FORD E4OD "UPDATE HANDBOOK"

*Updated
April, 2004*

VALVE BODY, SPACER PLATE, SPACER PLATE GASKETS, CHECKBALL LOCATIONS, AND CASE CHANGES, FOR THE 1996 MODEL YEAR

Figure 84
AUTOMATIC TRANSMISSION SERVICE GROUP
105

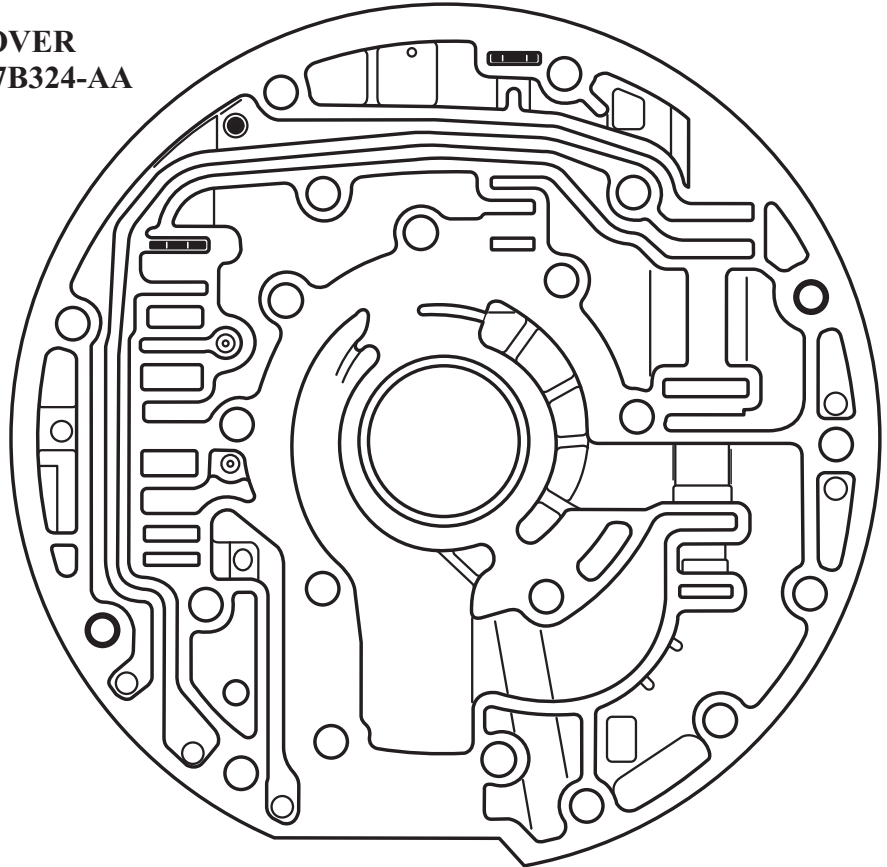
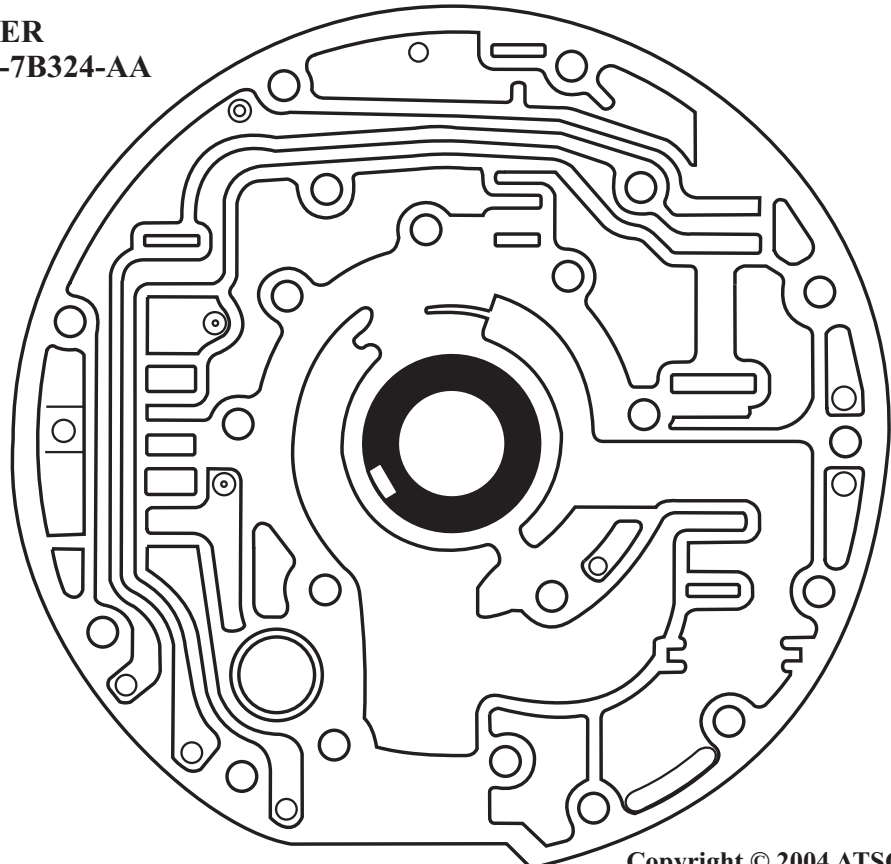
- (2) OIL PUMP COVER - Now has different worm tracks to accommodate two different styles of converter clutch valve line-ups, and has one added bolt to clamp the pump halves together. The worm track side of the new pump cover and the previous pump cover are illustrated in Figure 84, and casting number on new pump cover is RF-F81P-7B324-AA for identification.

Figure 85

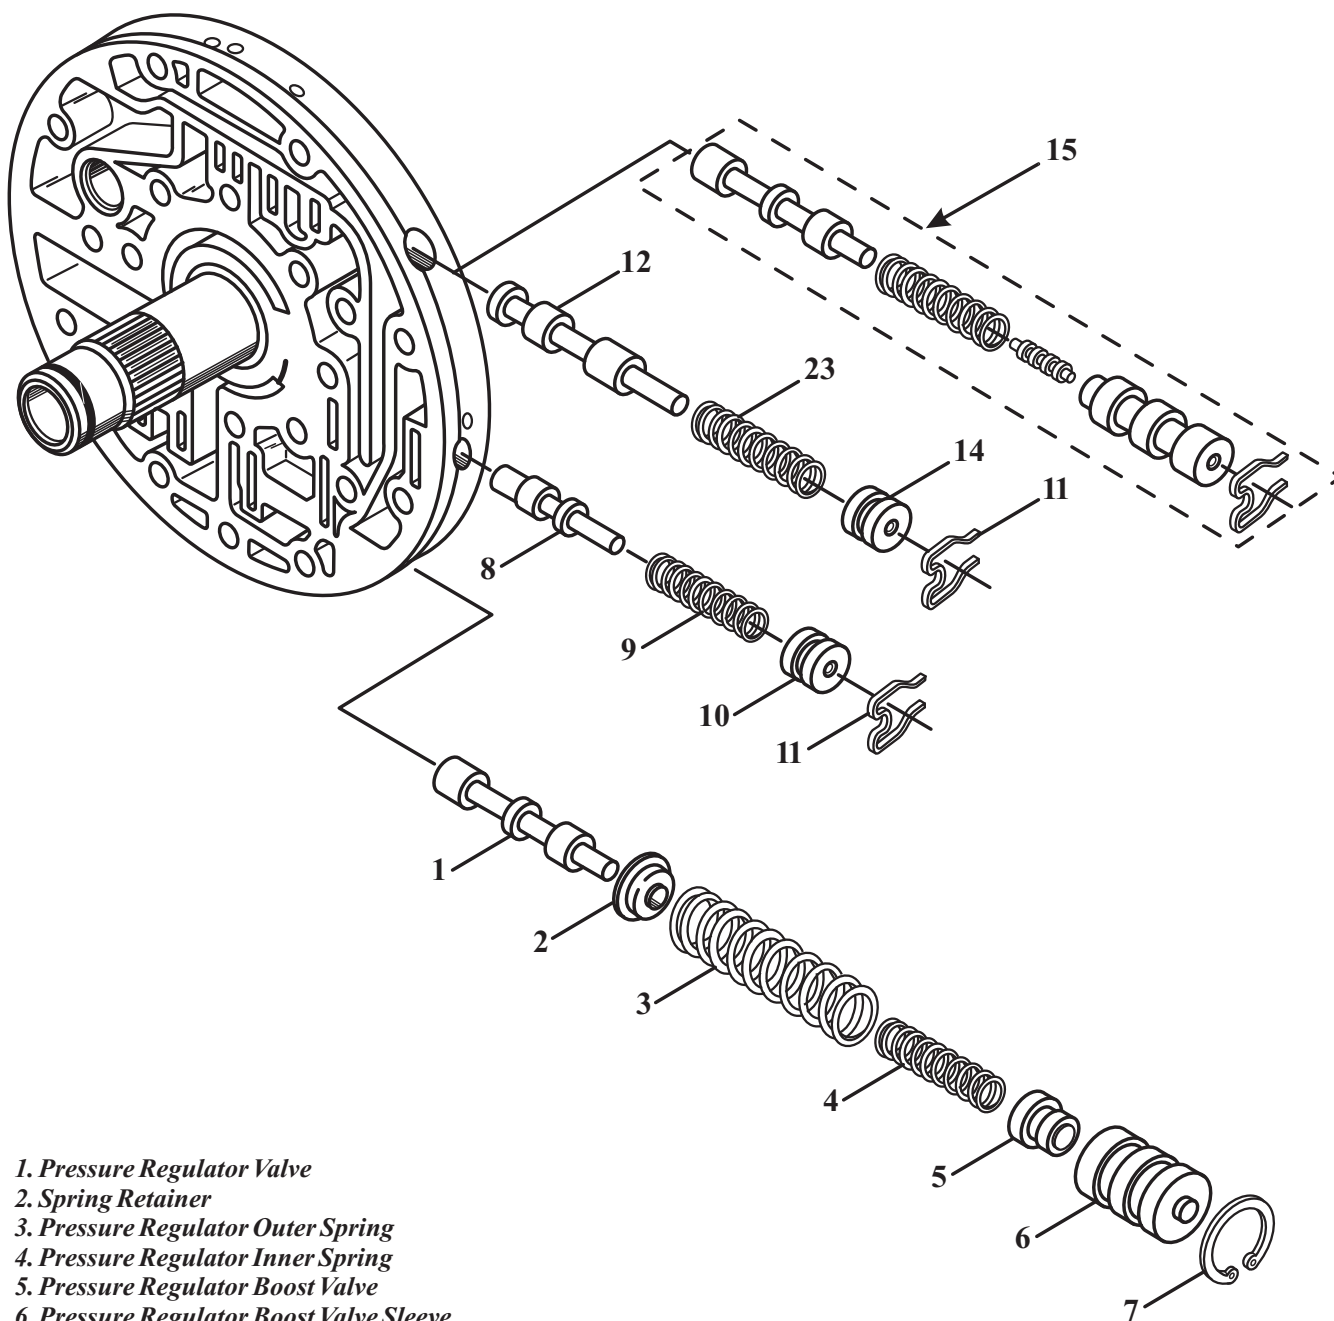
- (3) TCC LINE-UP - There are now two different Converter Clutch Control Valve Line-Ups in the oil pump cover depending on whether it is gasoline or diesel engine. Both of these valve line-ups are illustrated in Figure 85.

Figure 90

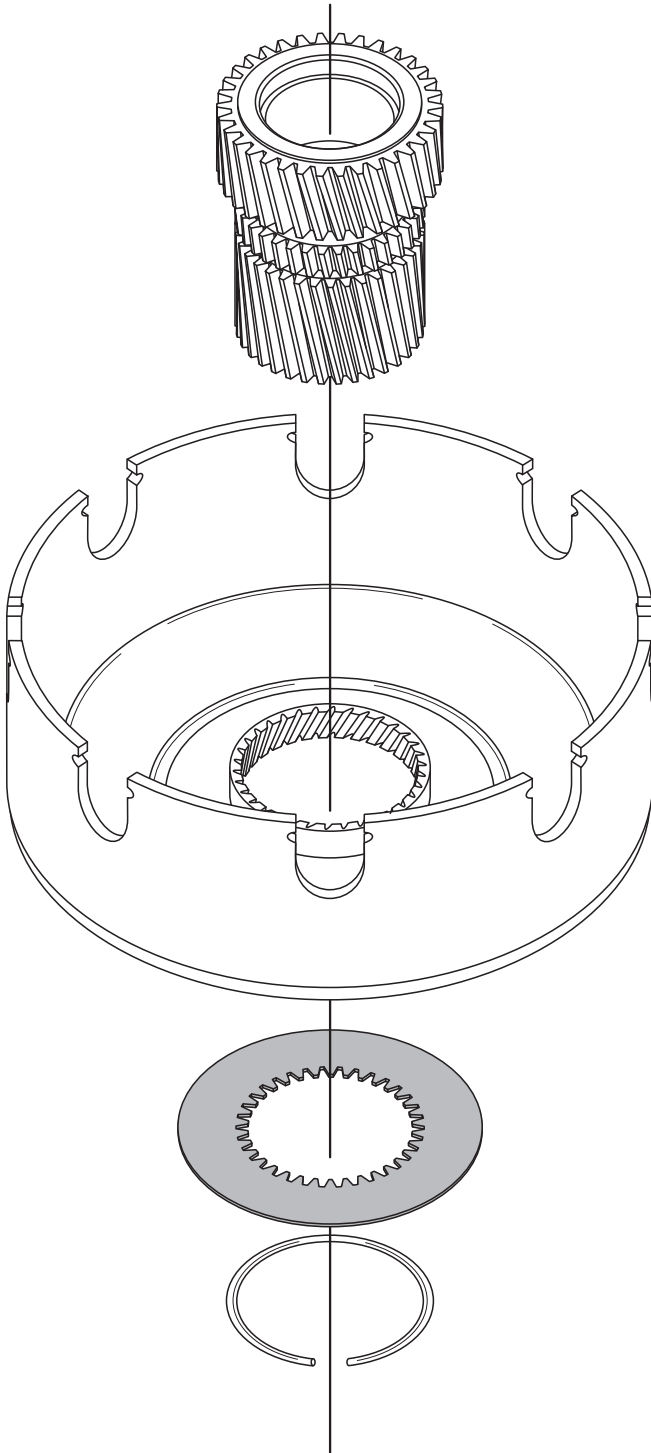
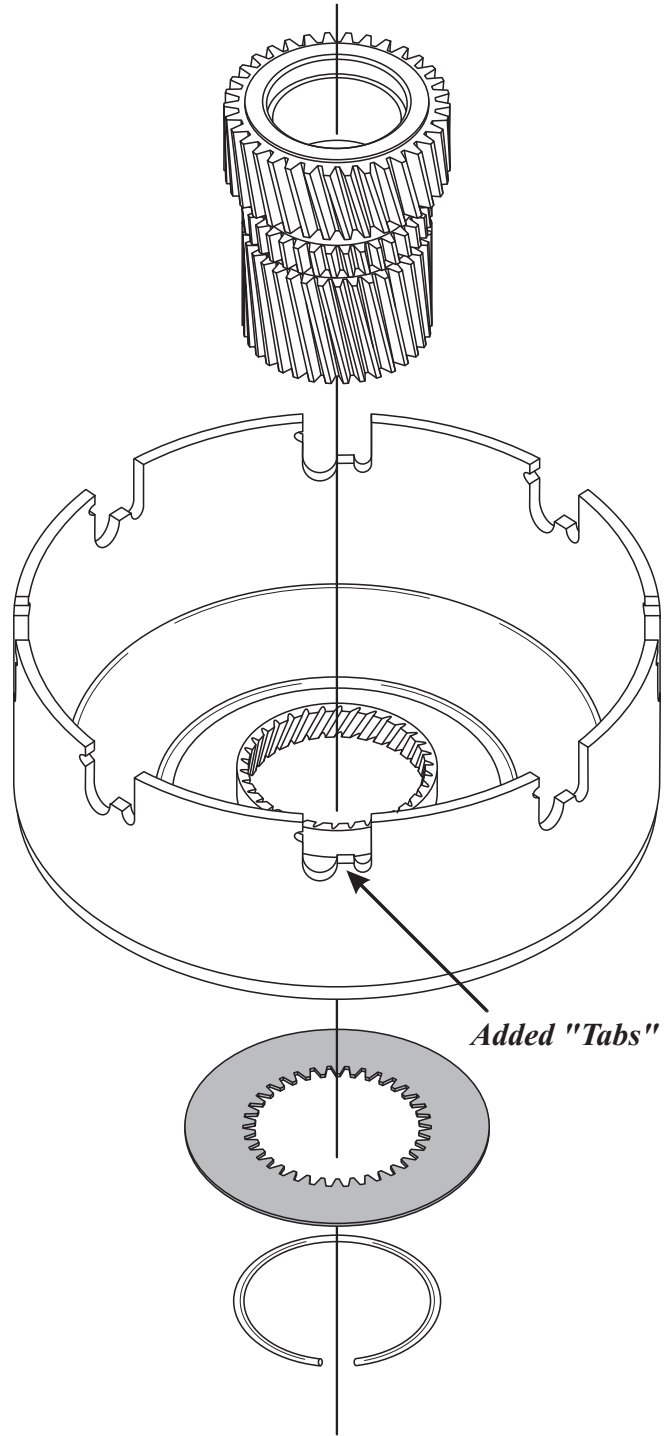
*May Be Used With "ONLY"
The Previous Design Direct Drum
And Requires The No. 8 Washer
(See Figure 91)*

*May Be Used With
Both Design Direct Drums
With Or Without Washer
(See Figure 91)*
